**CITY OF TEMPE
DEVELOPMENT REVIEW COMMISSION**

Meeting Date: 10/23/2018
Agenda Item: 4

ACTION: Request a Use Permit Standard to reduce the front setback from 20 feet to 16 feet and a Development Plan Review for a new 28-unit attached single-family development for LOFTS ON 8TH, located at 1403 East 8th Street. The applicant is 8th Street Developers, LLC.

Floor Plans

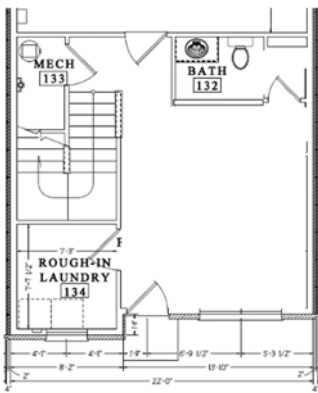
The attachments, as proposed, consists of den/office/optional bedroom on ground floor. Staff is recommending that the walls be removed from the ground floor to provide for an open common living space and eliminating the optional fifth bedroom so that the floor plan lends itself more towards a single-family townhome product (Condition #14). Additionally, the third-floor floorplan consists of a layout with three bedrooms and three bathrooms and an alternate floor plan with two bedrooms with one shared bathroom and master bedroom suite with walk-in closet and bathroom. Staff has conditioned the applicant use the "Alternate Third Floor Plan" in lieu of the "Third Floor Plan" to provide a floorplan that contains a true master bedroom suite (Condition #15).

14. Sheet A1.0 first floor of all units:
 - a. Remove the den/office/optional bedroom and closet.
 - b. Remove the shower to design a ½ bathroom.
 - c. First floor to provide open floorplan for general living space as shown below.

15. Eliminate Sheet A1.2 "Third Floor Plan" and utilize Sheet A1.21 "Alternate Third Floor Plan" with a master bedroom that is larger than the other bedrooms and contains amenities such as a walk-in closet, and the remaining bathroom is shared.
